RE: Planning Board Subdivision & Site Plan Review Applications
Proposed 3-Lot Subdivision, 437 Lafayette Road, Portsmouth, Tax Map 229, Lot 1

Planning Board Subdivision & Site Plan Review Applications **May 25, 2022**
Proposed 3-Lot Subdivision, 437 Lafayette Road, Portsmouth, Tax Map 229, Lot 1

Comments Received from TAC on May 2, 2022

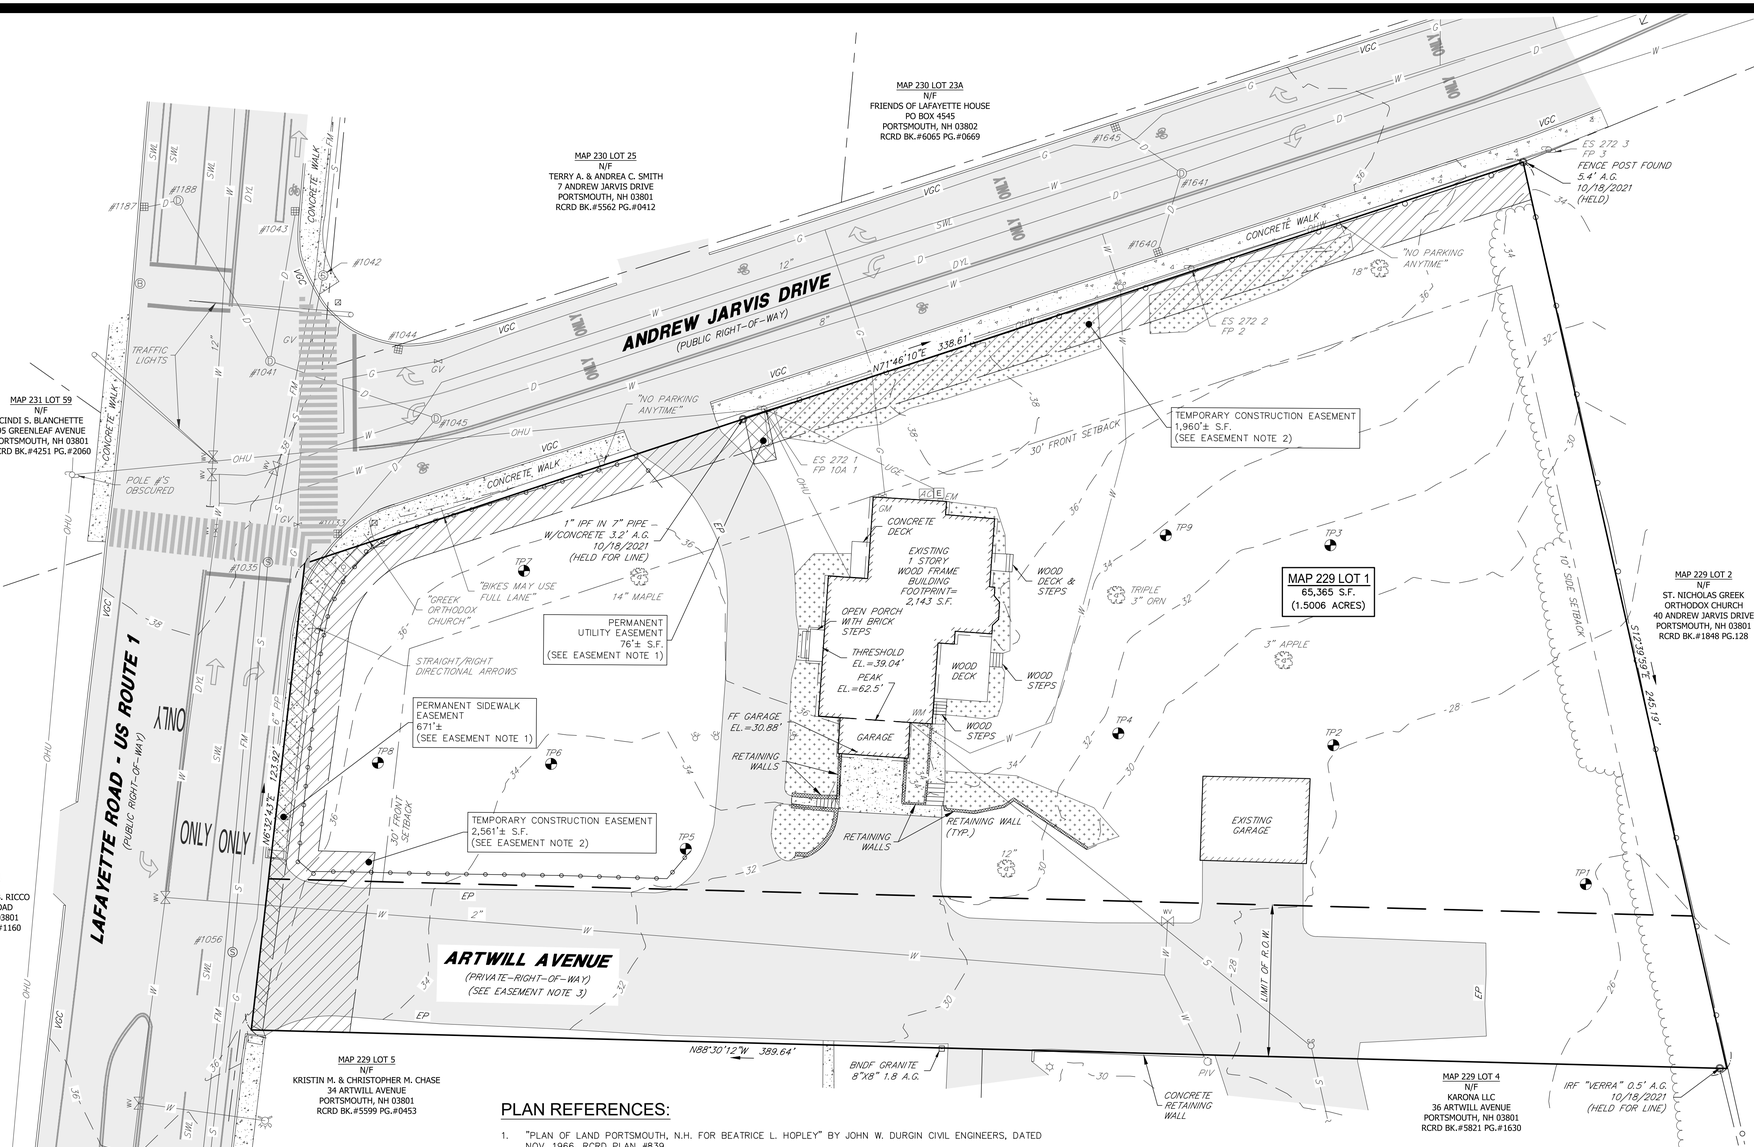
2. Ensure easements are provided for access across all proposed lots.
   Access easements are provided for all proposed lots and are shown and described on the Subdivision Plan. Please see sheet S-03.

3. Provide maintenance agreement for proposed road maintenance.
   A road maintenance agreement is provided with this submittal.
4. Provide an easement plan that identifies each easement with a unique identifier and corresponds to an easement table.
   Existing and proposed easements are shown and described on the Subdivision Plan. After discussing this matter with TAC at the May 2, 2022 meeting, it was determined that a separate Easement Plan is not necessary. Please see sheet S-03.

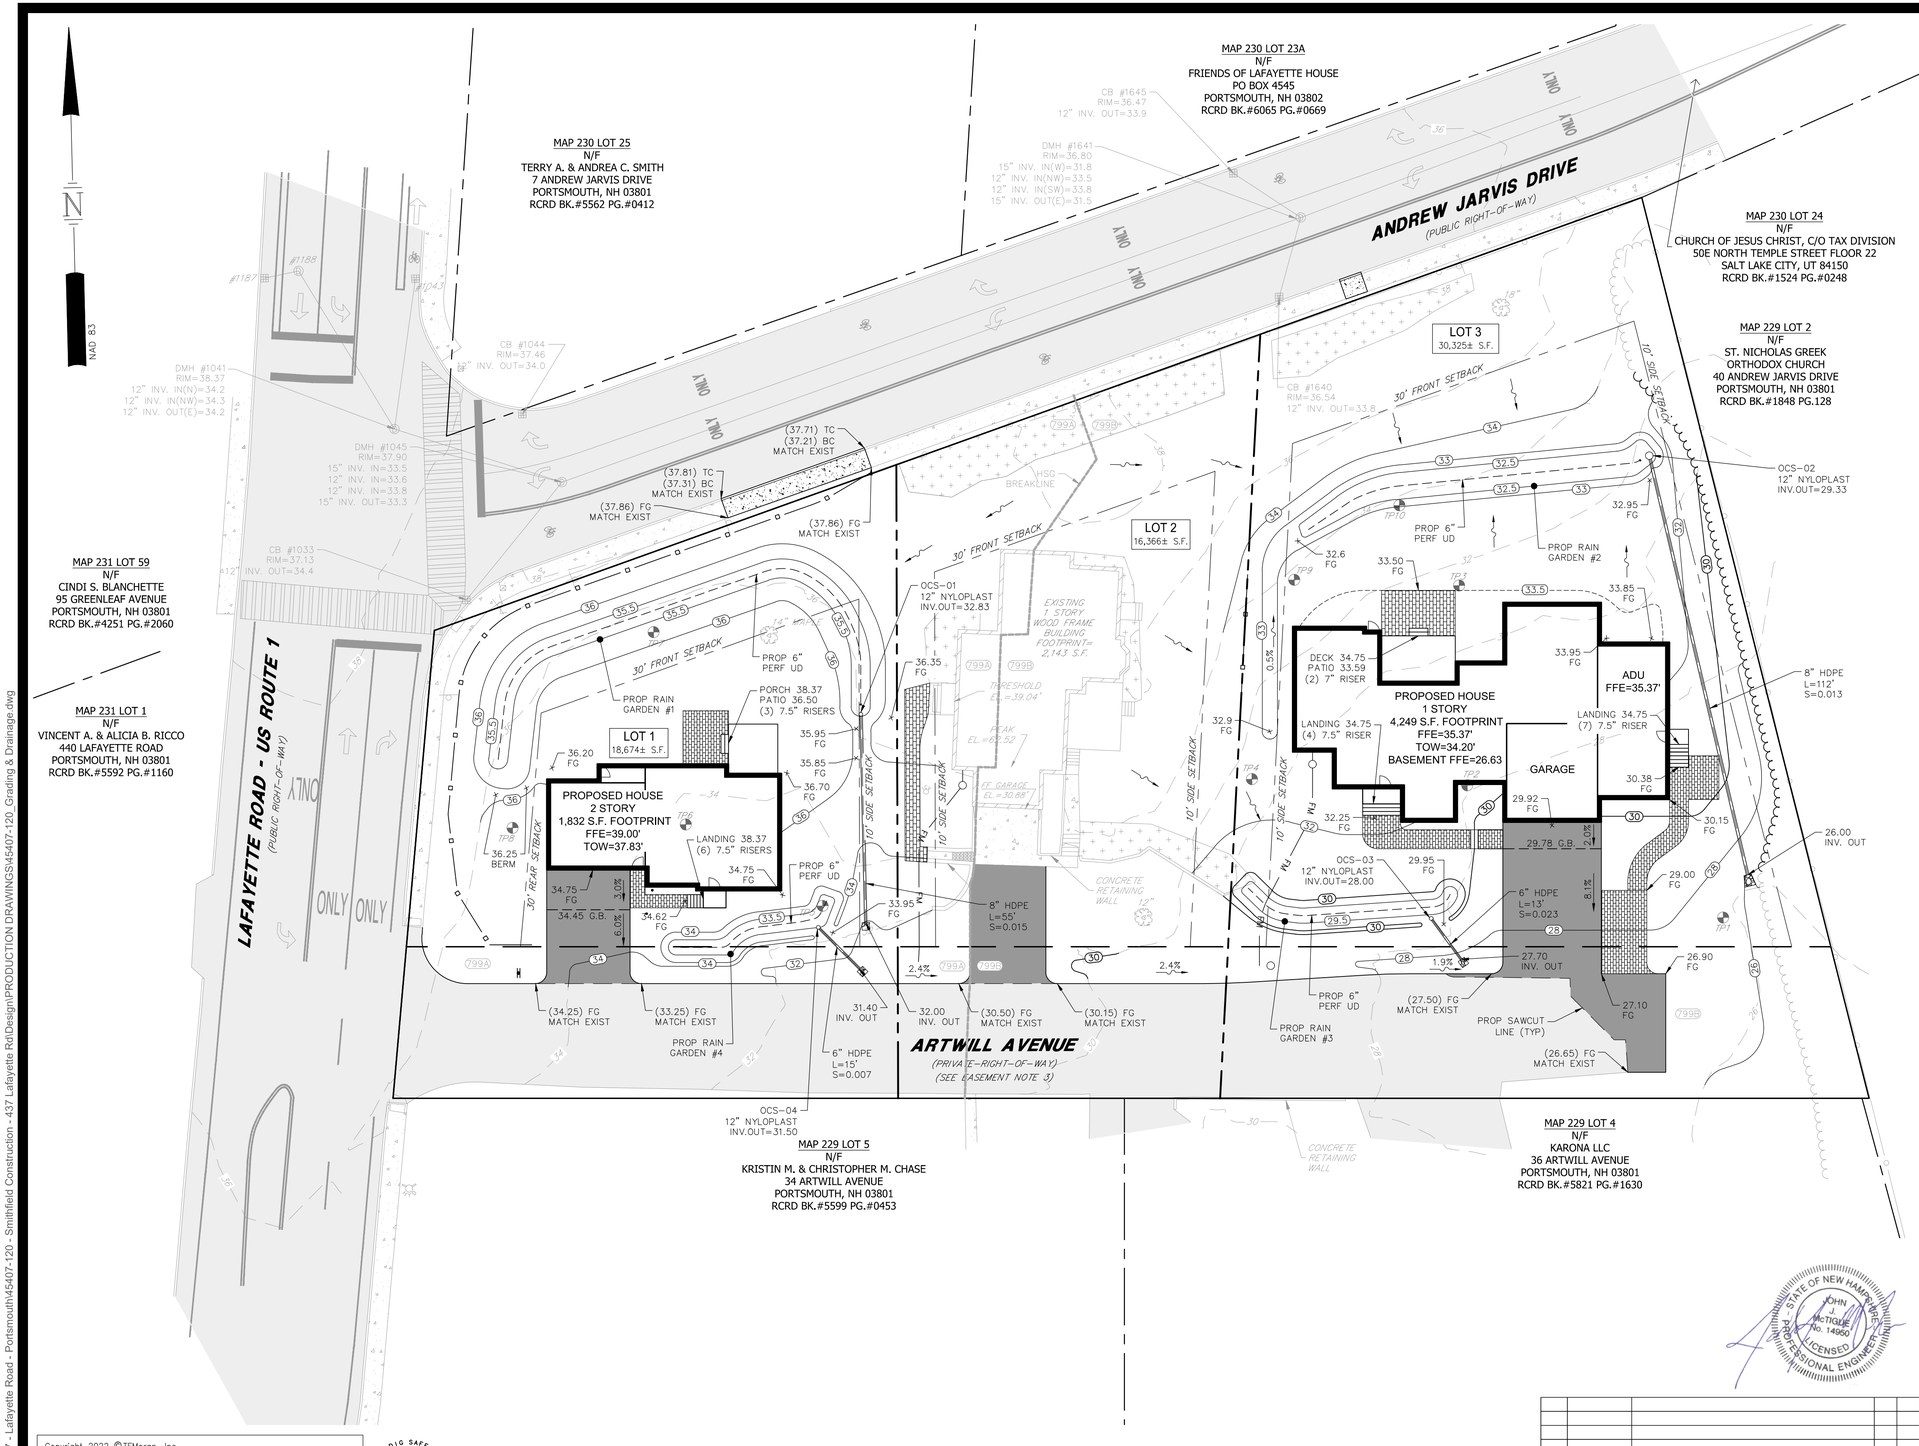
1. Gas line to be installed under Artwill Ave and service shall come from that side.
   A new gas main will be installed on Artwill Avenue with service connections made to the proposed houses on Lot 1 and Lot 3. The proposed gas main will connect to an existing gas main located in Lafayette Road at the intersection of Artwill Avenue and Lafayette Road. Unitil has reviewed our plan and approved the layout. Please see sheet C-05.

5. Coordinate final connections of water and sewer services with Portsmouth Water.
   Further coordination with the City Water Department has transpired with regards to final water and sewer service connections. The Water Department has approved the water and sewer connections shown on our plans.
6. Final connection to which main under Andrew Jarvis Dr will be determined by Portsmouth Water.
   Through additional coordination, the City Water Department has requested that the 8" water main on Andrew Jarvis Drive be used for water service connections. The Utility Plans have been revised accordingly. Please see sheet C-05.
